Project	IEEE 802.16 Broadband Wireless Access Working Group < <a href="http://ieee802.org/16">http://ieee802.org/16</a> >	
Title	Routing Announcements for Network Entry Support	
Date Submitted	01/08/2007	
Source(s)	Shyamal Ramachandran Aparna Pandey Motorola, Inc. 1064 Greenwood Blvd. Ste. 400 Lake Mary, FL 32746	shyamal.ramachandran@motorola.com aparna.pandey@motorola.com
	Kenji Saito, Takashi Inoue KDDI R&D Laboratories Inc. Hikarino-oka 7-1, Yokosuka, Kanagawa 239-0847, Japan	saito@kddilabs.jp
	Hyunjeong Kang, Sungjin Lee, HyoungKyu Lim Samsung Electronics	hyunjeong.kang@samsung.com
Re:	Call for Technical Proposals regarding IEEE Project P802.16j (IEEE 802.16j-06/034)	
Abstract	IE that needs to be added to enable improved network entry support for relay stations.	
Purpose	Adoption of the proposed text into P802.16j	
Notice	This document has been prepared to assist IEEE 802.16. It is offered as a basis for discussion and is not binding on the contributing individual(s) or organization(s). The material in this document is subject to change in form and content after further study. The contributor(s) reserve(s) the right to add, amend or withdraw material contained herein.

# Routin

Figure 55a – RS Initialization overview

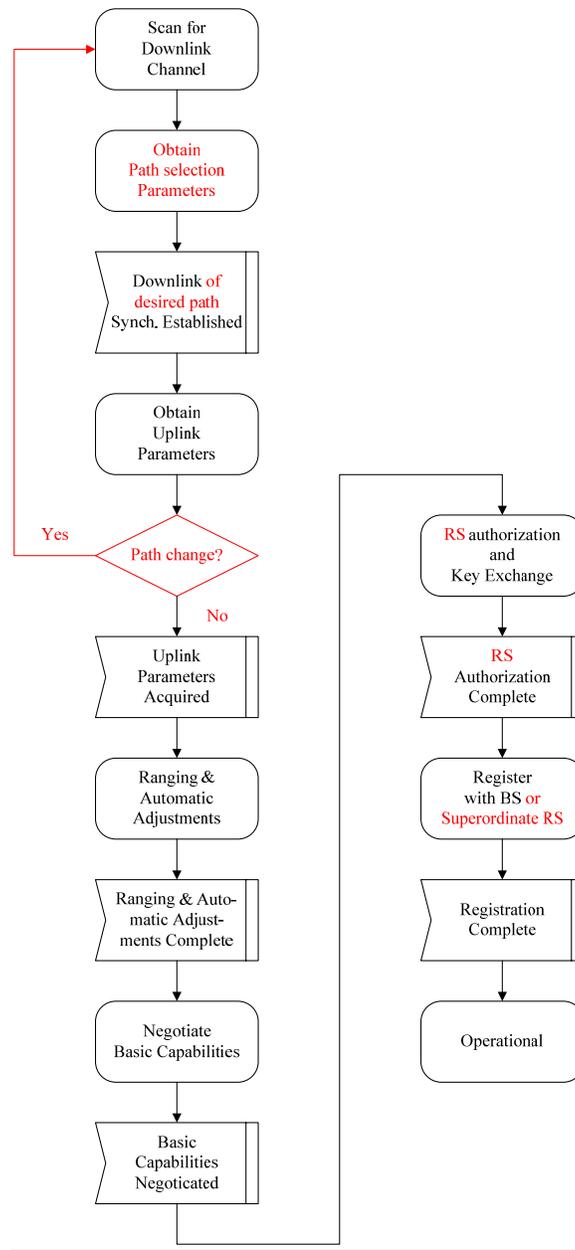
Figure 55a has been modified and shown below to depict the changes anticipated to the network entry procedure as a result of the incorporation of path selection.

The RS initial network entry procedure can be divided into the following phases:

- a) Scan for downlink channel and obtain path selection parameters
- b) Obtain transmit parameters (from UCD message)
- c) Decide a desired path and establish synchronization with the superordinate node (BS or RS)
- d) Perform ranging
- e) Negotiate basic capabilities
- f) Authorization RS and perform key exchange
- g) Perform registration
- h) Set up connections
